⚠ ADDENDUM No. 1

**MD 108 AND GREAT STAR DRIVE**

# TRAFFIC SIGNAL PLAN

DRAWING NO. TS - 3802C — SHEET NO. 26 OF 27

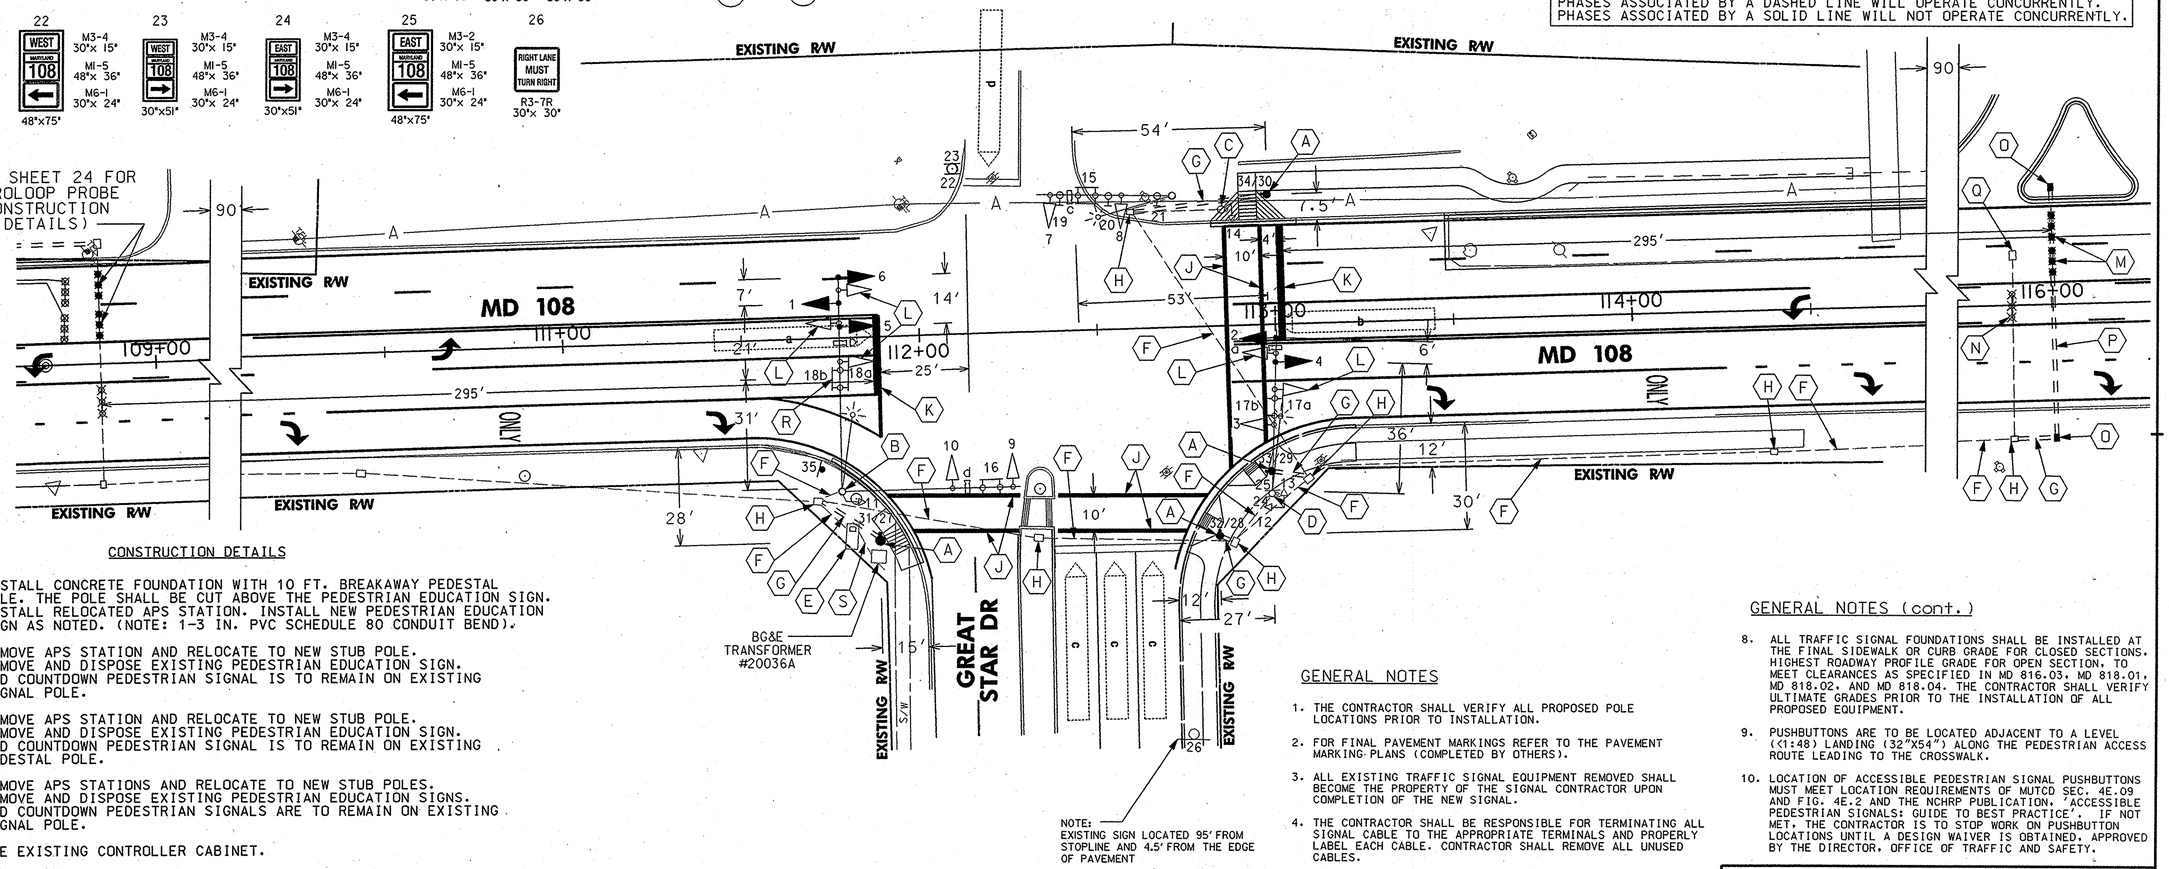
REVISIONS
C MODIFY PEDESTRIAN EQUIPMENT LOCATIONS FOR NEW INTERSECTION GEOMETRY. MODIFY SIGNAL HEAD ALIGNMENT AND NON-INVASIVE MICROLOOP PROBES. FOR WB APPROACH. SHA NO.: H0888077 — S.W. SDY 11/8/07 12/28/07
B 11-2005 SIGNAL MODIFICATION DUE TO NEW GEOMETRICS (NO. CO. CAPITAL PROJECT NO.:T-7020) — KJS
A 10-01-98 AS BUILT SHA NO.: BW177M83 — RRZ

A. INSTALL CONCRETE FOUNDATION WITH 10 FT. BREAKAWAY PEDESTAL POLE. THE POLE SHALL BE CUT ABOVE THE PEDESTRIAN EDUCATION SIGN. INSTALL RELOCATED APS STATION. INSTALL NEW PEDESTRIAN EDUCATION SIGN AS NOTED. (NOTE: 1-3 IN. PVC SCHEDULE 80 CONDUIT BEND).

B. REMOVE APS STATION AND RELOCATE TO NEW STUB POLE. REMOVE AND DISPOSE EXISTING PEDESTRIAN EDUCATION SIGN. LED COUNTDOWN PEDESTRIAN SIGNAL IS TO REMAIN ON EXISTING SIGNAL POLE.

C. REMOVE APS STATION AND RELOCATE TO NEW STUB POLE. REMOVE AND DISPOSE EXISTING PEDESTRIAN EDUCATION SIGN. LED COUNTDOWN PEDESTRIAN SIGNAL IS TO REMAIN ON EXISTING PEDESTAL POLE.

D. REMOVE APS STATIONS AND RELOCATE TO NEW STUB POLES. REMOVE AND DISPOSE EXISTING PEDESTRIAN EDUCATION SIGNS. LED COUNTDOWN PEDESTRIAN SIGNALS ARE TO REMAIN ON EXISTING SIGNAL POLE.

L. RELOCATE EXISTING SIGNAL HEAD ON EXISTING MAST ARM.

M. INSTALL NON-INVASIVE MICROLOOP PROBE.

N. REMOVE EXISTING MICROLOOP PROBE.

R. RELOCATE EXISTING STREET NAME SIGN ON EXISTING MAST ARM TO LOCATION AS SHOWN.
